Re: Encroachment - Letter of Intent

GLWA, is planning to perform improvements at their Hubbell Southfield Combined Sewer Overflow (CSO) Facilities in the City of Dearborn. In coordination with the work being performed at the Hubbell Southfield facility, GLWA is proposing to refurnish two level sensors within the City of Detroit. GLWA is proposing to refurnish a level sensor at West Chicago and Hubbell at 9523 Hubbell (L-201).

# HUBBELL-SOUTHFIELD CSO FACILITY IMPROVEMENTS

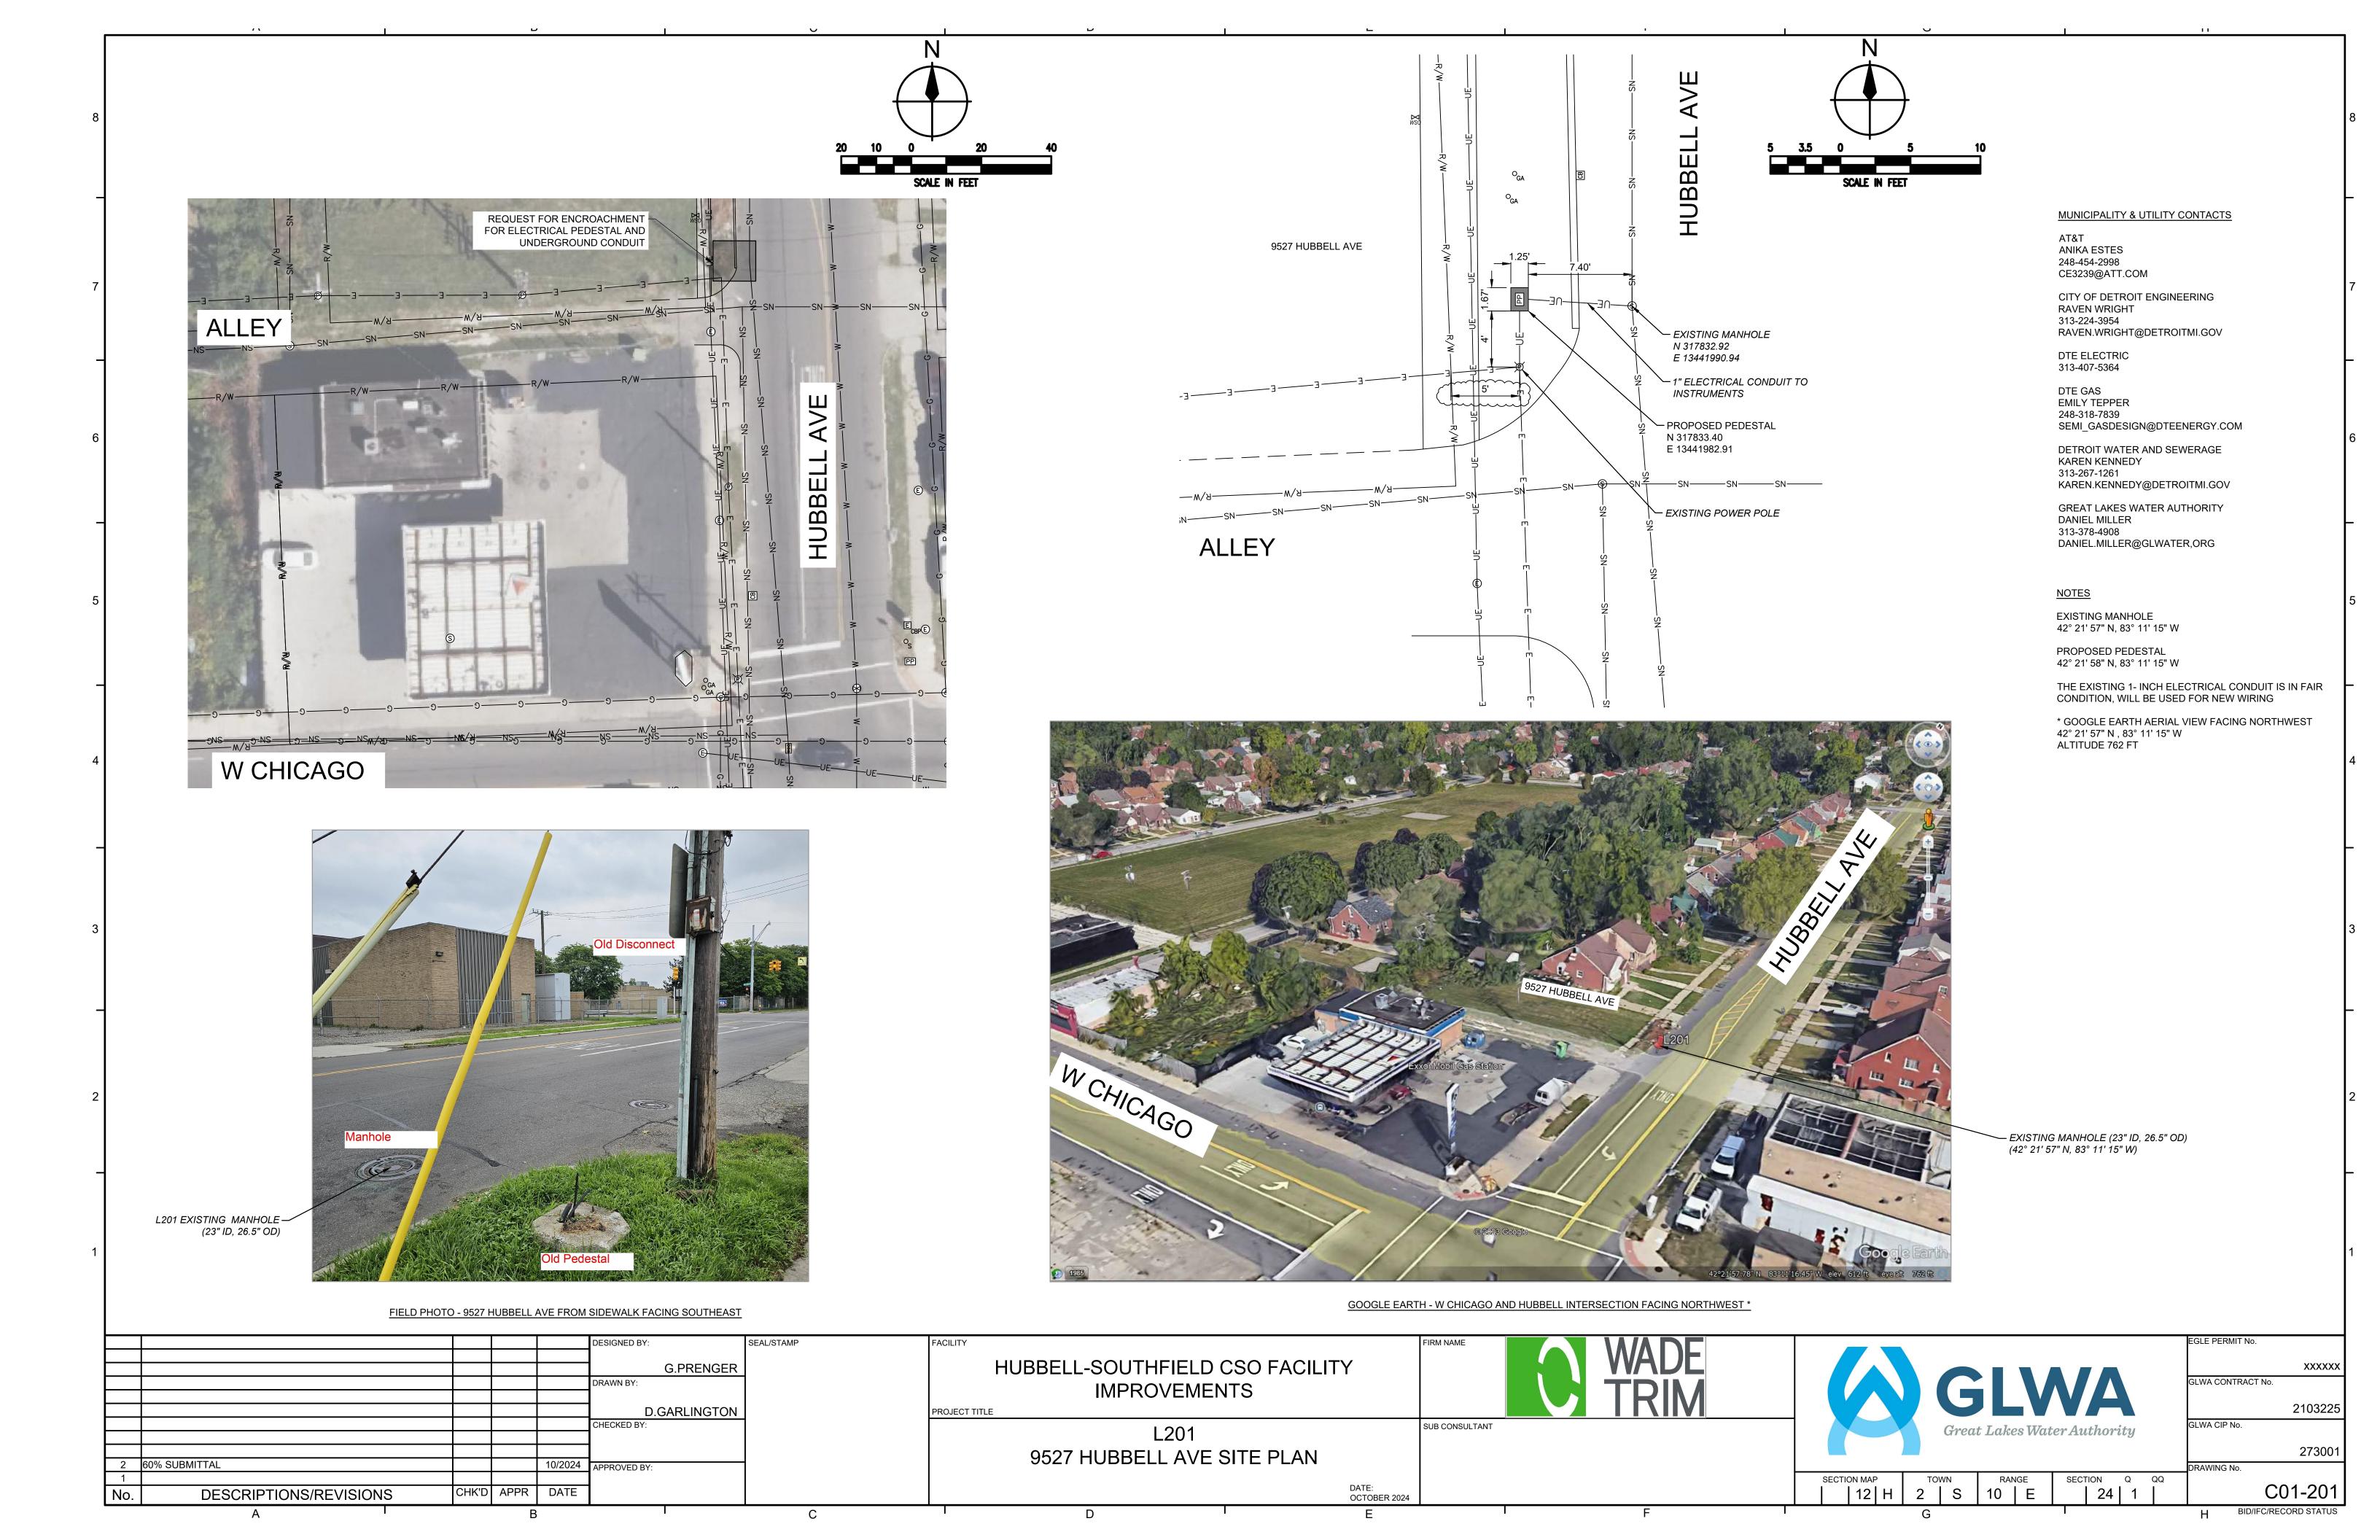
Please help with the following questions and the dimensions marked by XX.

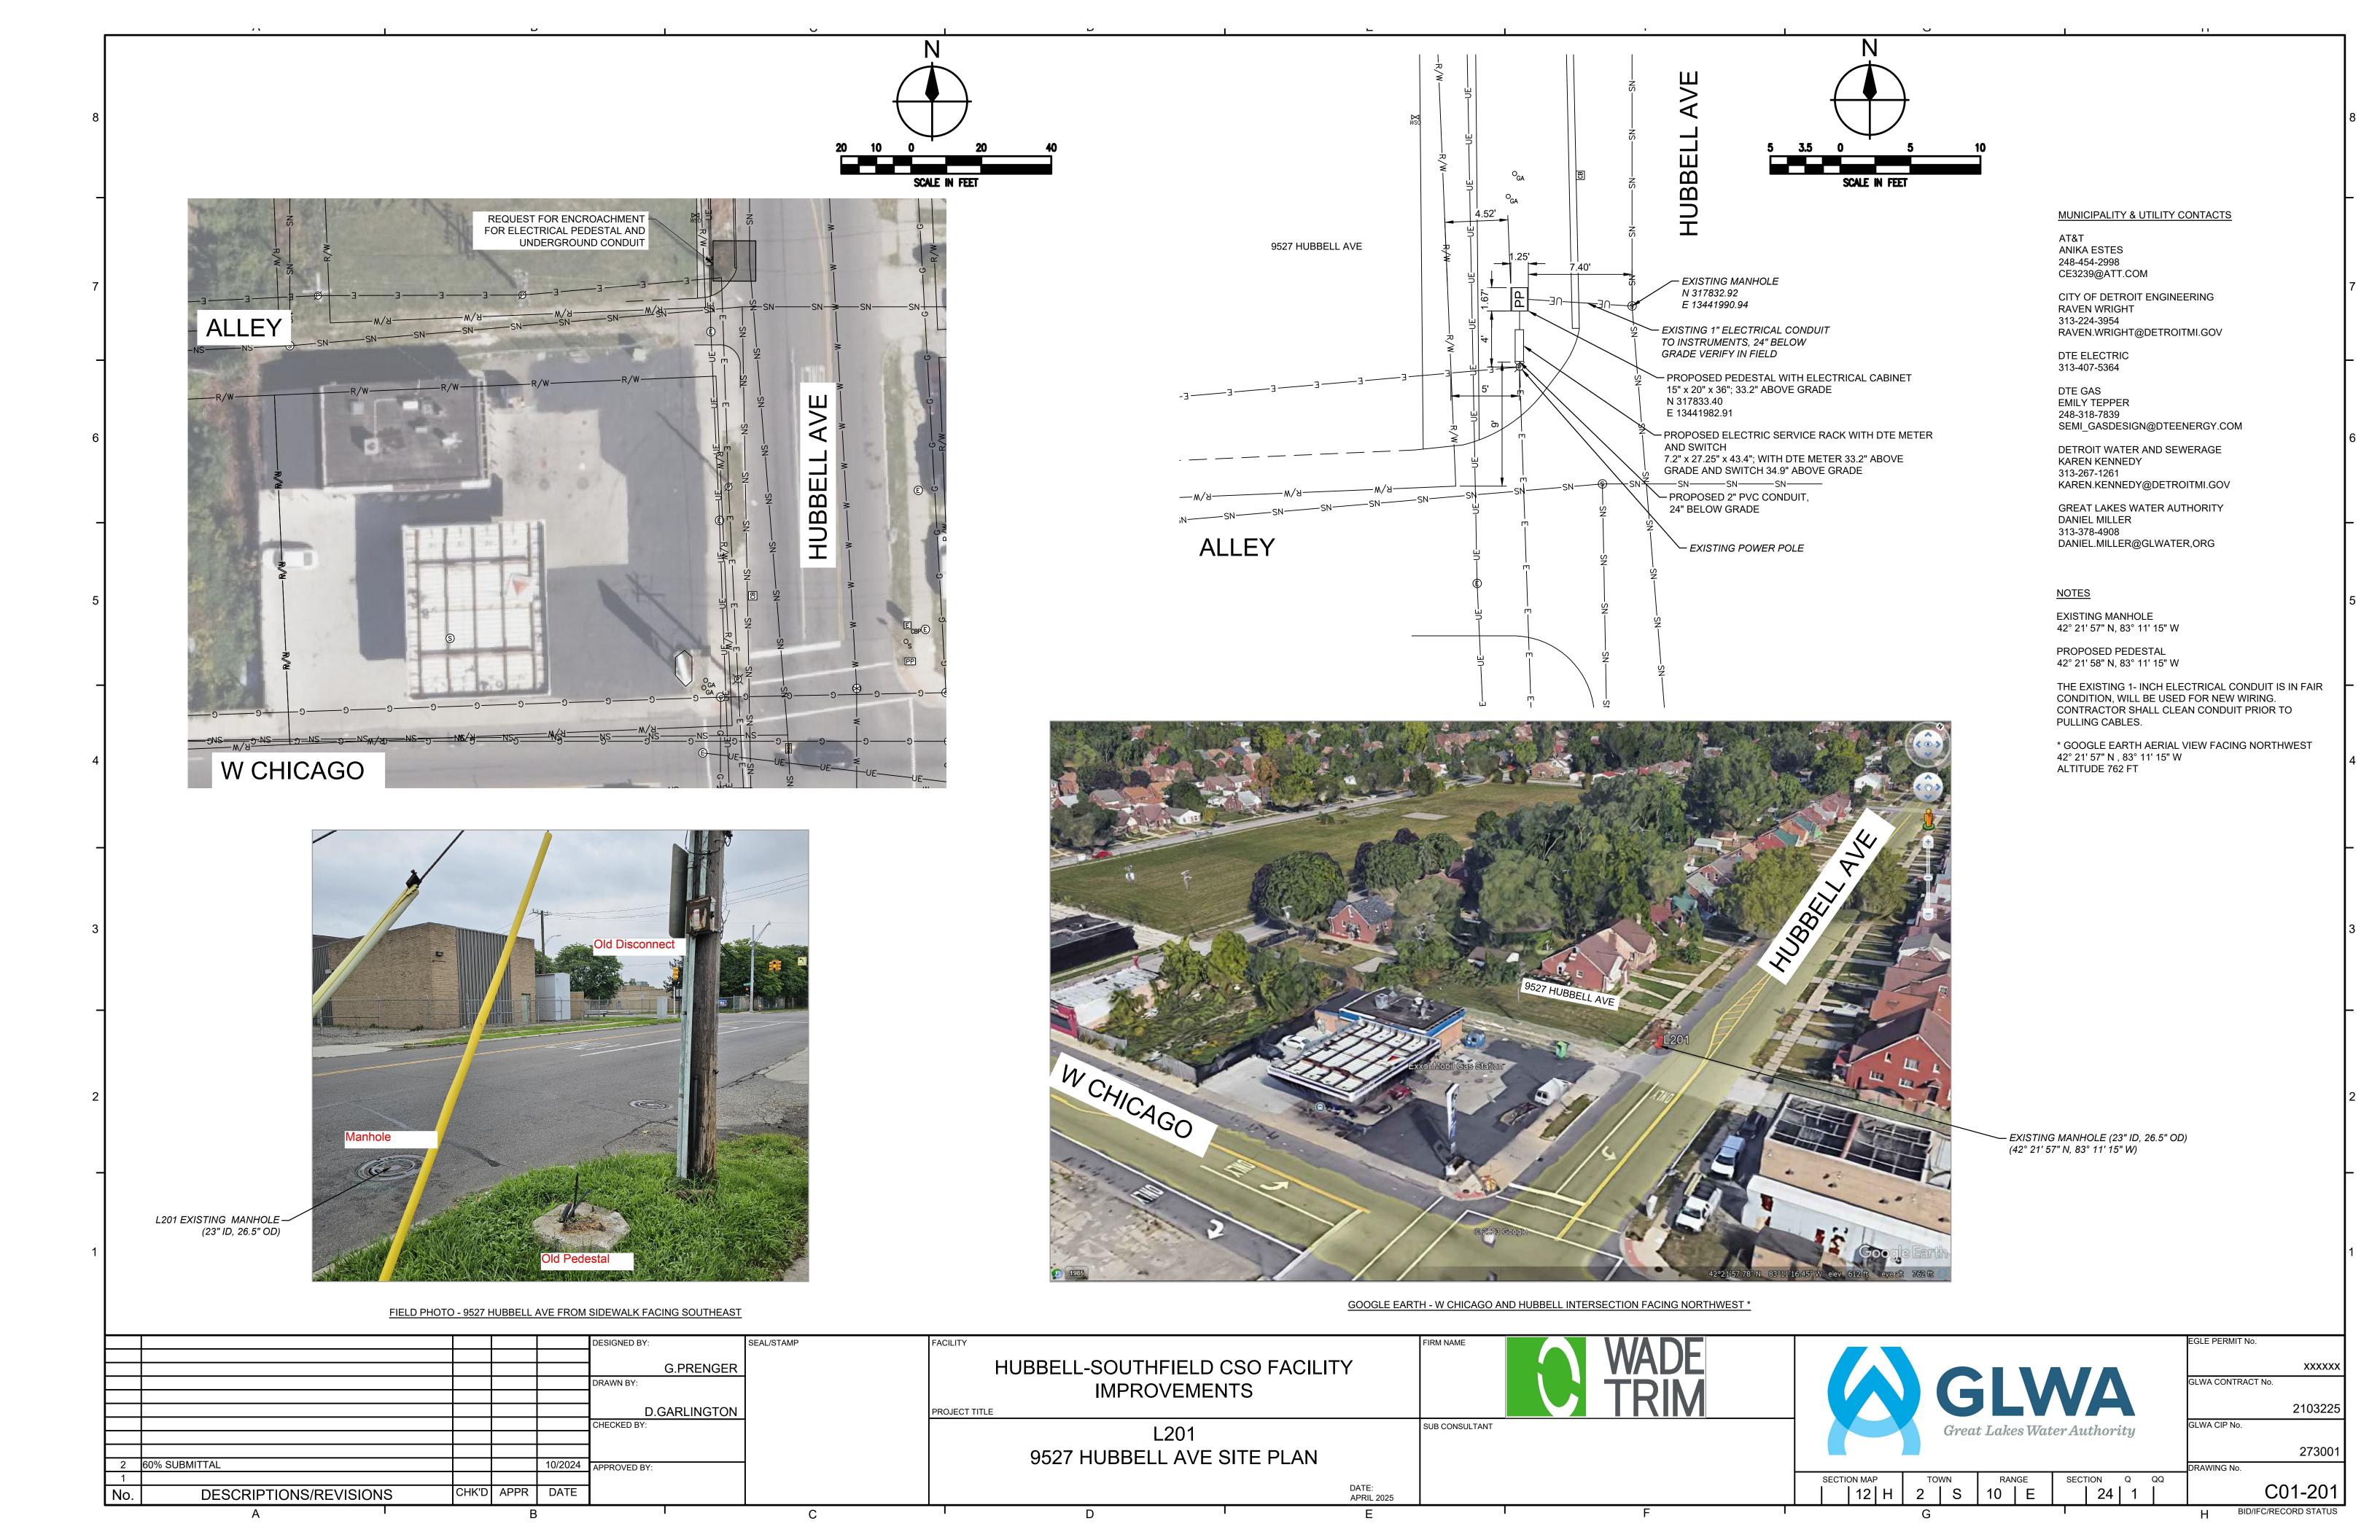
Page four of the site plan shows one proposed pedestal. Page nine shows a pedestal with a box and another meter box.

What is the distance from the property lines?

How deep are the below grade conduits?

What is the height of the pedestal with the electrical cabinet?

What is the height and depth of the meter box? (27.25 wide x 42"min to 6'max to top of meter box x how thick?)
